## OICA comments on EFV-08-04

### Parameter: Regulated Pollutants

**Reference Document:**

EFV 07-03: Regulated Pollutants

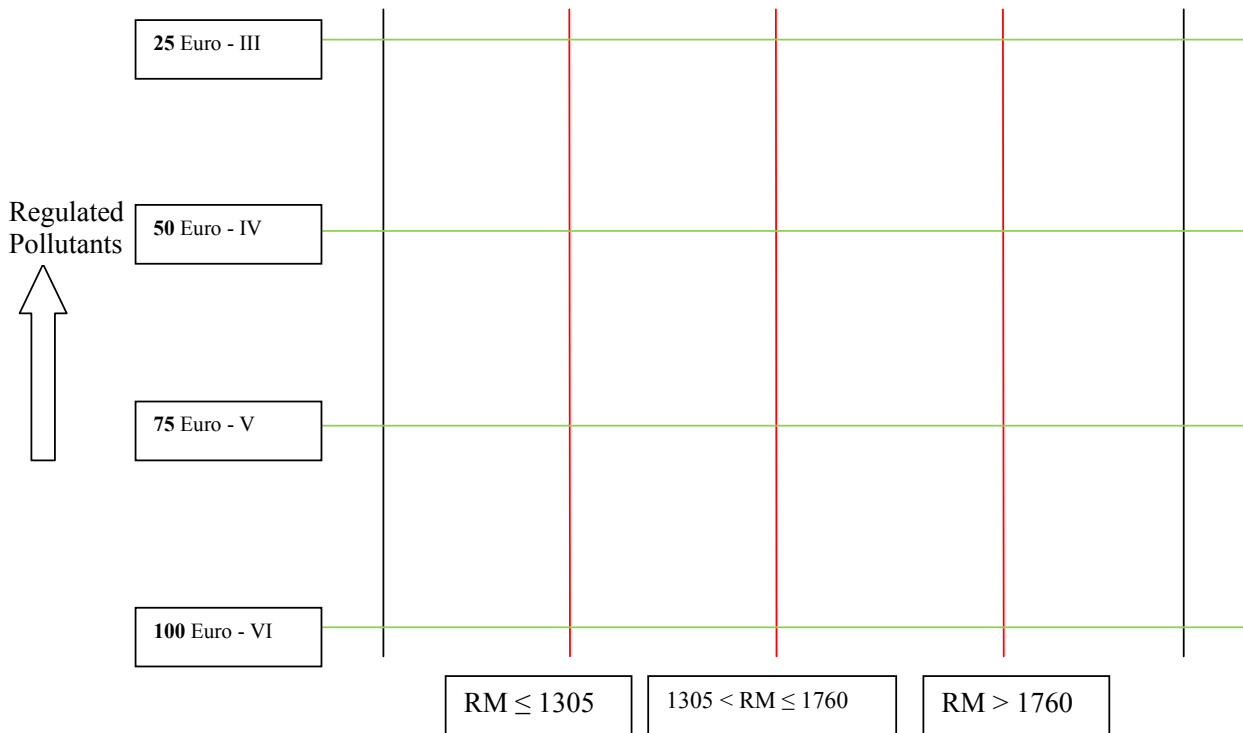
Comment [WPS2]: The assessment of what is 50% is dependent on the region.

This approach is purely based on the regulatory norms. The existing regulations as well as future regulations are consolidated to formulate the approach. The European regulatory norm Euro – III for passenger car is taken as a base line (Critical, because the value of Euro 3 differs from region to region ...). Below this norm, no or zero score will be given to the vehicle. The Euro – VI has given the full 100 score. (WHAT is the procedure, when Euro 7 comes along ? – Transient, planned ?)
